PROPOSED REVISIONS TO PREVIOUSLY APPROVED BUILDING ZONE AND
CLEARING LIMITS OF LOT 3 OF THE VERCON ASSOCIATES 16-LOT SUBDIVISION.

Subject: Proposed Revisions to Building Zone & Clearing Limits
 Lot 3, Vercon Associates 16-Lot Subdivision
 Jaren & Erica Wilcoxson, 0 Grey Birch Road (11-227.030)

Project #22130

SITE PLAN
JAREN & ERICA WILCOXSON
GREY BIRCH ROAD
STOWE, VERMONT

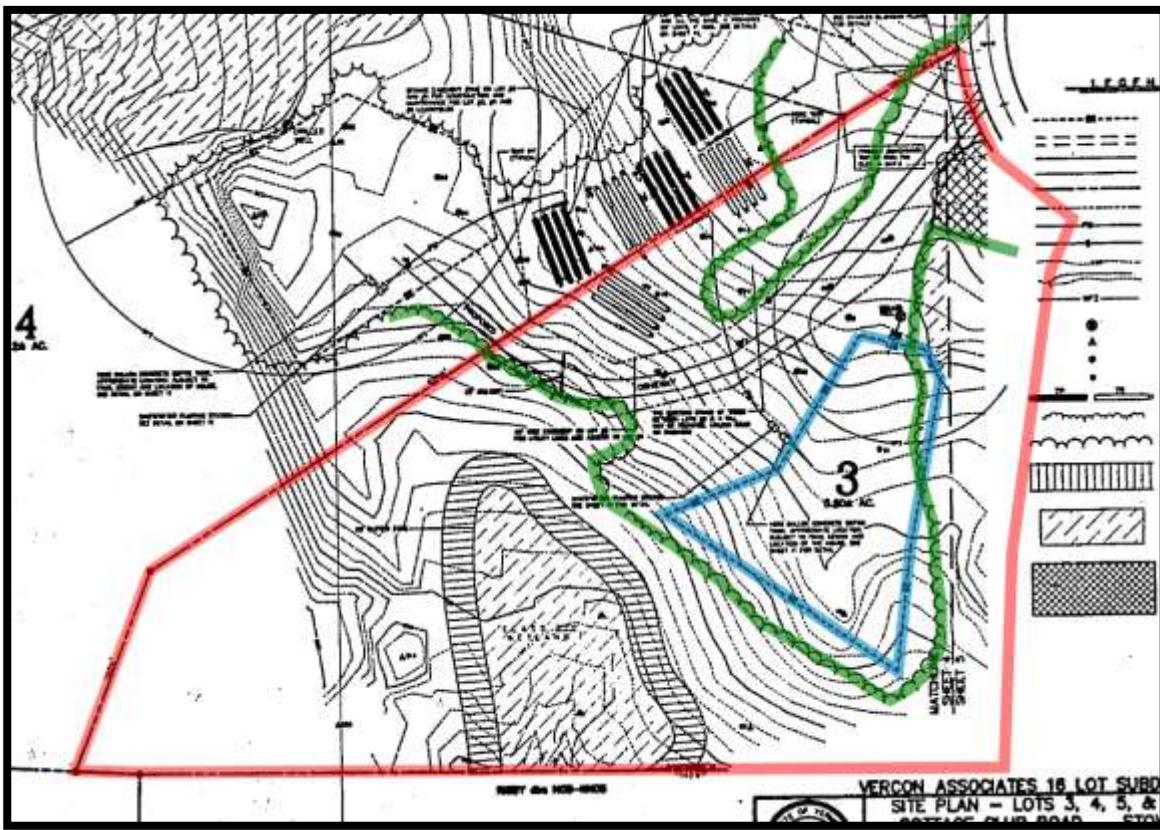
The Vercon Associates 16-lot subdivision included proposed building zones and clearing limits for Lot 3 as shown on the Charles Burnham Site Plan, originally dated August 1994:

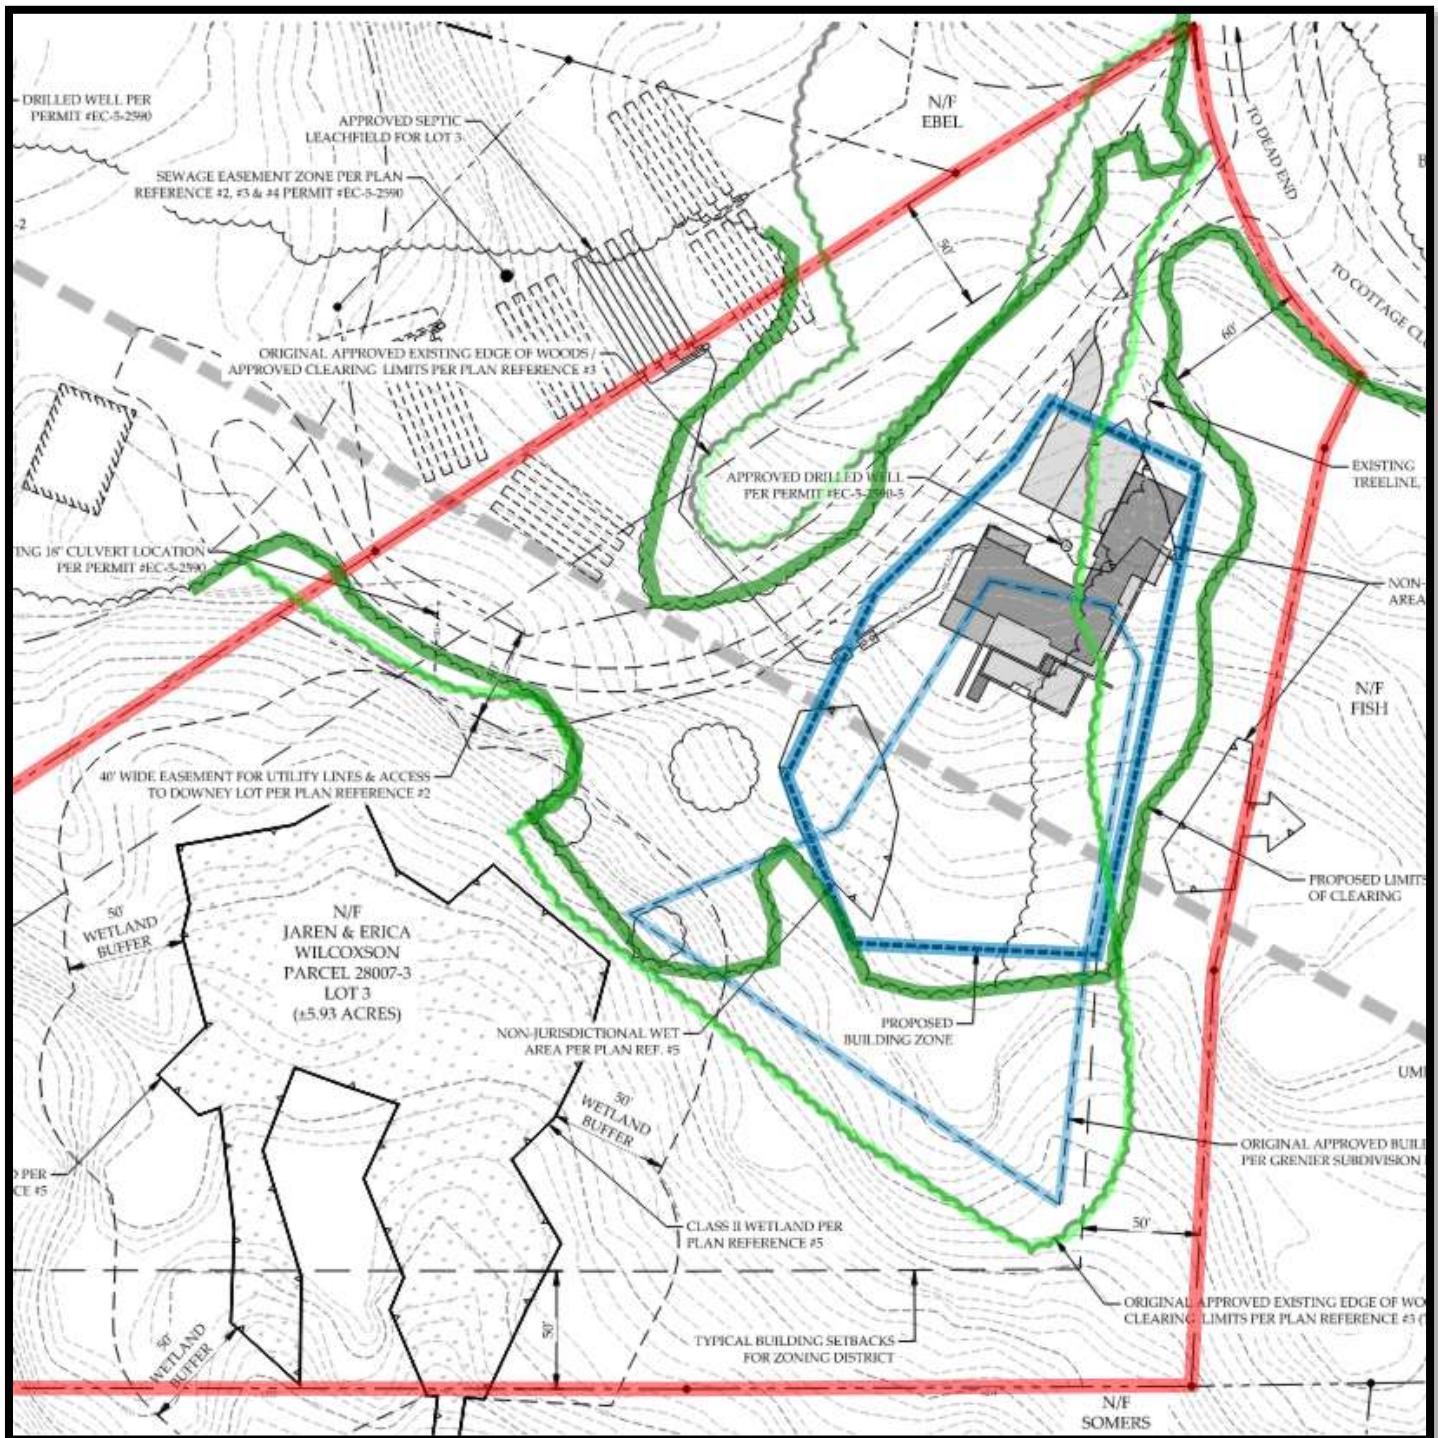
The building zone and clearing limits of Lot 3 were revised and approved by the Town of Stowe in 2001, under Permit #S-01-20, as shown on the Charles Grenier Site Plan:

The 2001 approval modified the shape of the building zone and shifted it uphill. The clearing limits appear to have been only slightly revised, with the proposed tree line moving further uphill (with the building zone) and enlarged slightly at the uphill side of the new building zone.

SHEET NO.C-1
1 OF 1 SHEETS

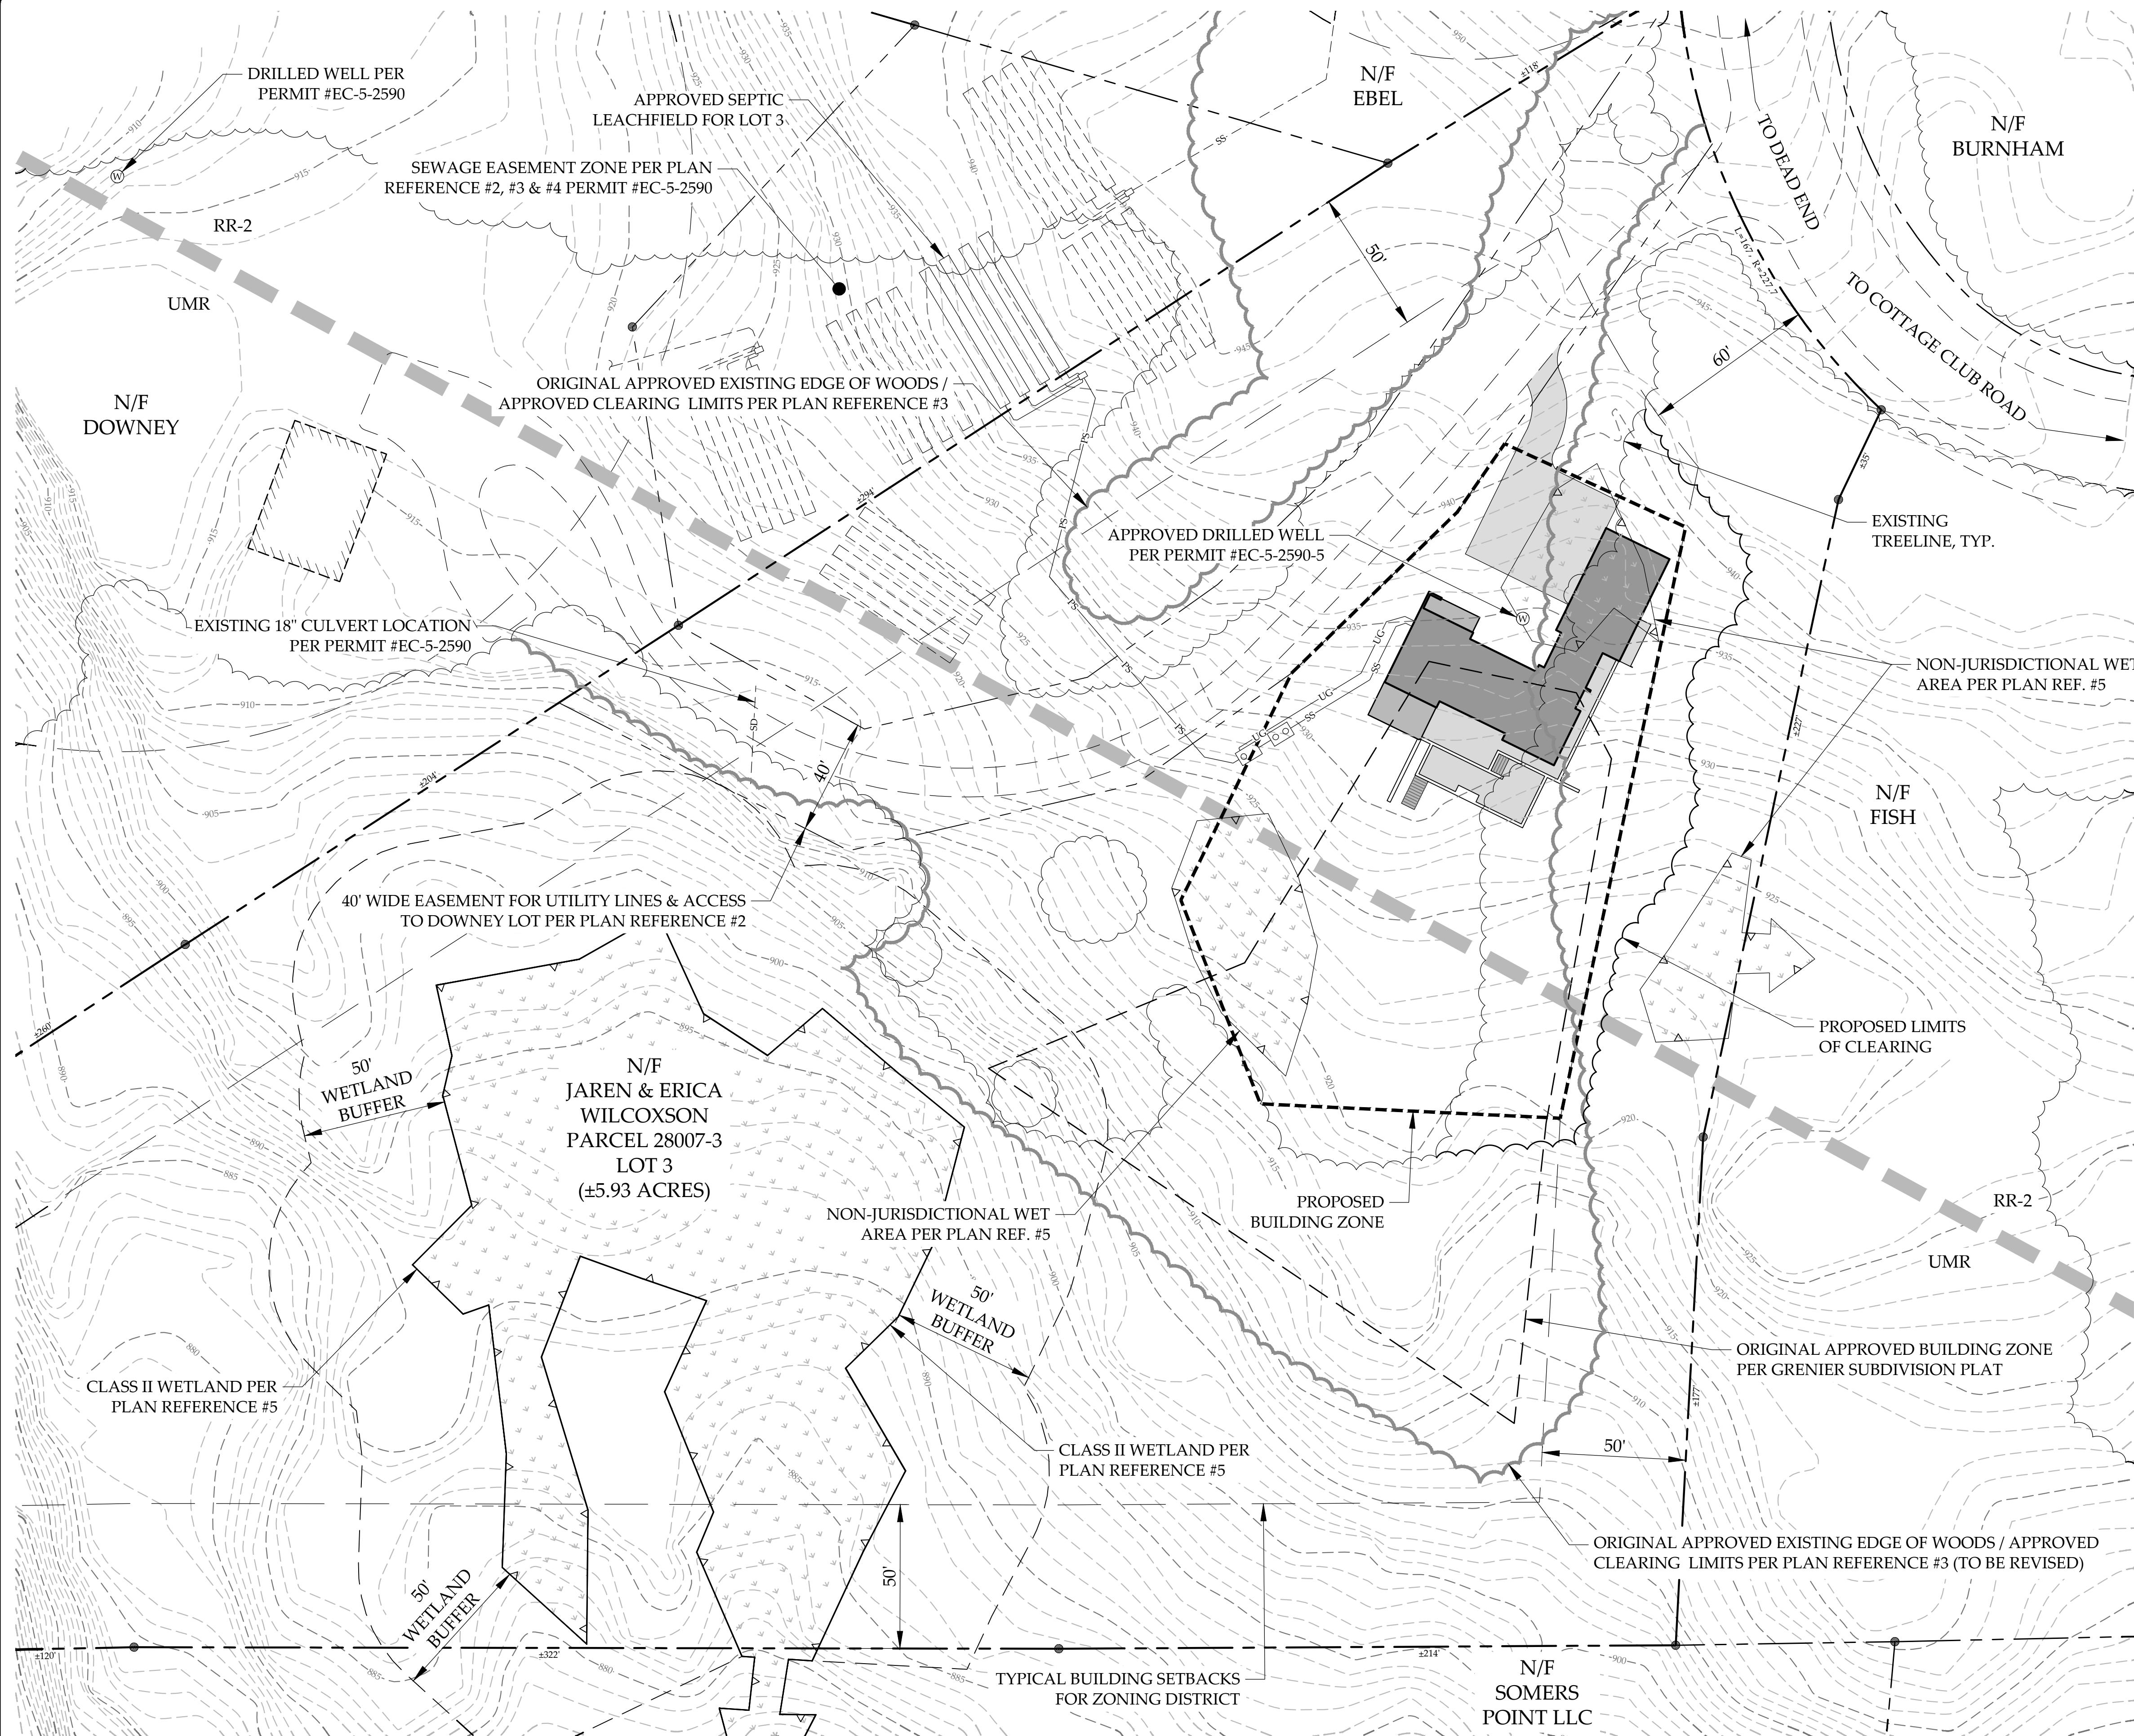
The proposed building zone is revised to follow the typical UMR and RR2 setback (50 feet) along the east portion of the property, and run along the existing shared driveway easement along the western portion. The south portion is moved uphill from the previously approved building zone. The new building zone is slightly smaller in area.

The proposed clearing limits are revised to correspond with the new building zone along the east side of the property. In this area, there will be an adequate amount of wooded area to remain in order to maintain screening and privacy for the lot to the east (n/f Fish). On the south downhill side, the clearing limit is significantly reduced to allow for more vegetation to remain, which helps combat the recent clear cutting of Hob Knob development. Overall, the proposed clearing limits are reduced in area compared to the previously approved area. Further, the originally designed fire pond at the north end of Lot 3 is no longer required, therefore the existing vegetation in this area is proposed to remain.

The proposed Site Plan by Mumley Engineering shows the previously approved and the new proposed building zones. It also shows the previously approved clearing limits, the existing tree line, and the proposed limits of clearing.

PROPOSED REVISIONS TO THE PREVIOUSLY APPROVED BUILDING ZONE AND CLEARING LIMITS ON LOT 3 OF THE VERCON ASSOCIATES 16-LOT SUBDIVISION.
